FINAL MITIGATION PLAN
Harrell Mitigation Site

Jackson County, NC
Project Number: 100005
Contract Number: 7006
RFP: 16-006811

Reference: Harrell Site Draft Mitigation Plan

Re: NCIRT Review and USACE Approval of the Harrell Stream and Wetland Mitigation Plan; SAW-2016-02202; NCDMS Project # 100005

Revision Sheet
0 P-1

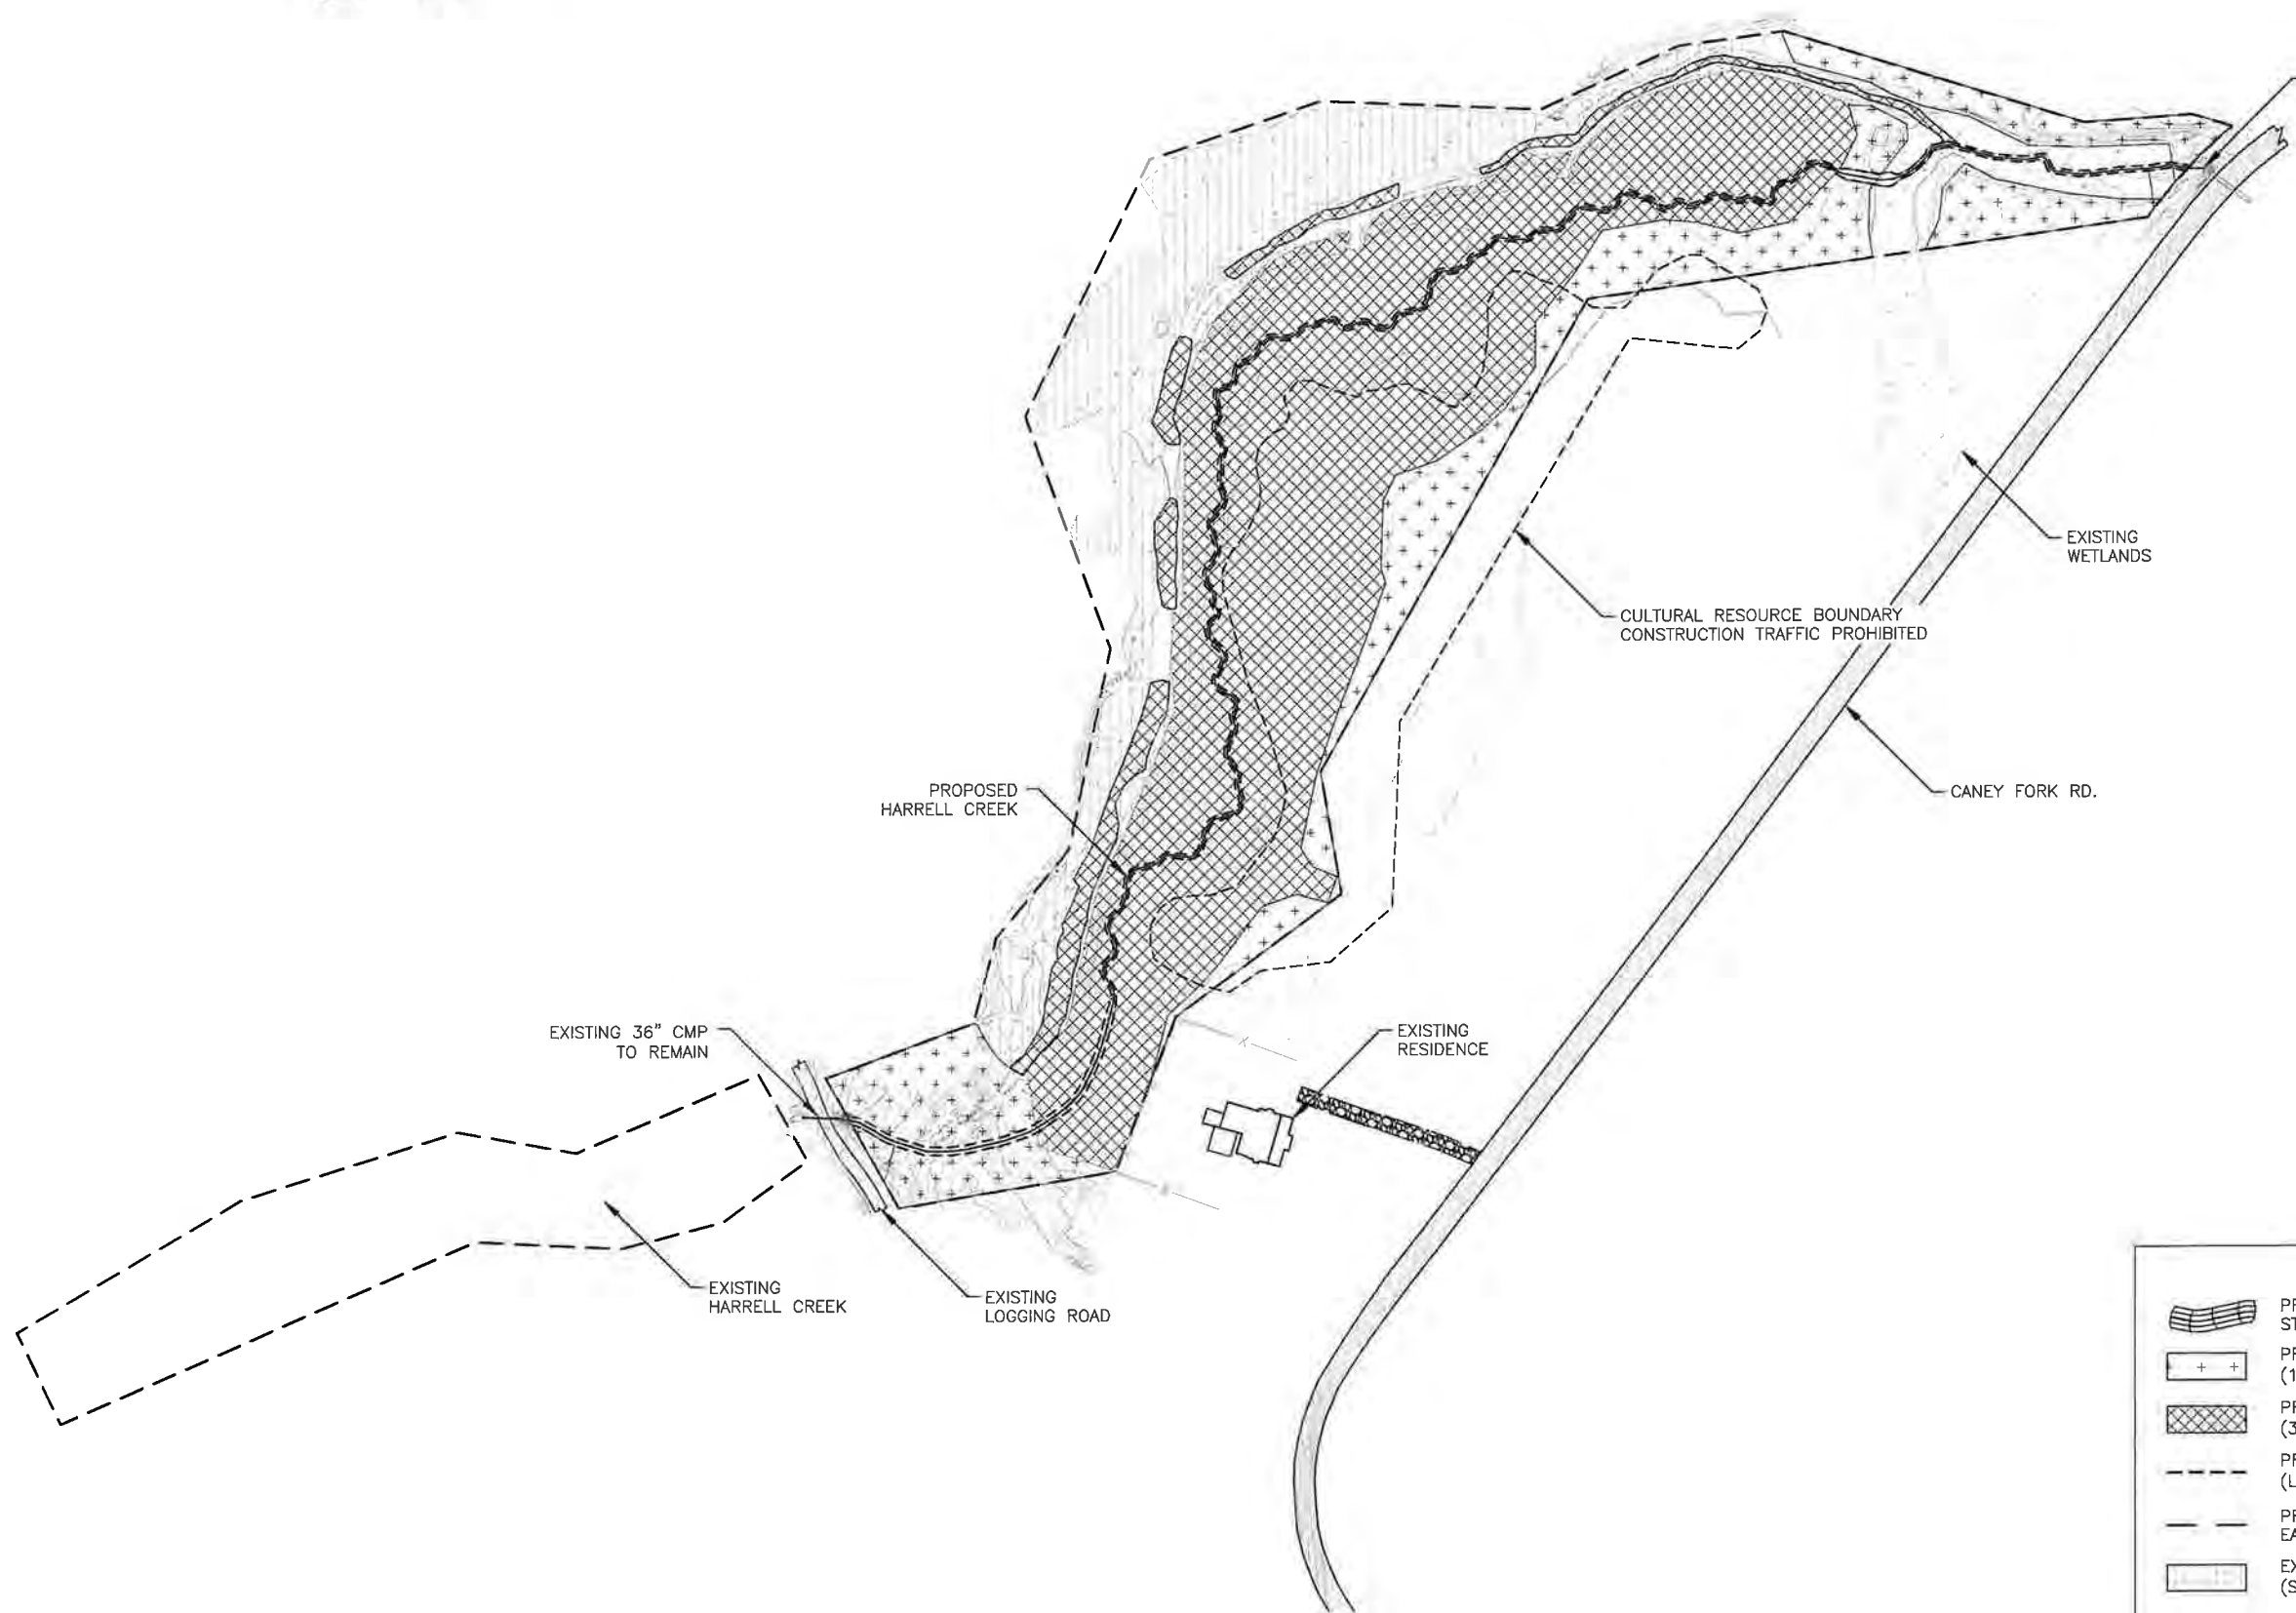
Comment: The project planting plans do not address the different community types other than “wetland” and “riparian” planting zones.

Comment: Recommend adding the percentage of each species included in planting plans to avoid any one species comprising more than 50% of stems planted.

Comment: Target community of Swamp-Forest Bog is not addressed in this section or in the planting plan of Page 189.

Comment: The planting plan does not include Swamp-Forest Bog plant community

Comment: According to arials, it appears that a large majority of the existing wetlands and the wetland re-establishment areas are forested yet these areas are proposed for planting on design sheet P-2? What is the acreage of woody vegetation that will be removed during construction?

Response: Due to the small area of replanting that will occur within the Piedmont/Mountain Semi permanent Impoundment community, the planting plan combines both wetland communities and is labeled as “Wetland Planting Zone.” An additional note has been added to the Planting Plan detailing this.

Response: The note within the Planting Plan Details of the design plans has been revised.

Response: Language has been added and the planting plan has been updated.

Response: The planting plan has been updated to include the delineation of the Piedmont/Mountain Semi permanent Impoundment community and the Swamp-Forest Bog community. As stated in a previous comment, the proposed planting does not differentiate between the two communities due to the small area of the Piedmont/ Mountain Semi permanent Impoundment community proposed to be planted.

Response: The proposed design will include the grading and replanting of a wooded area slightly larger than 1 acre. The majority of the woody material removed will be repurposed in the construction of the proposed channel and structures.
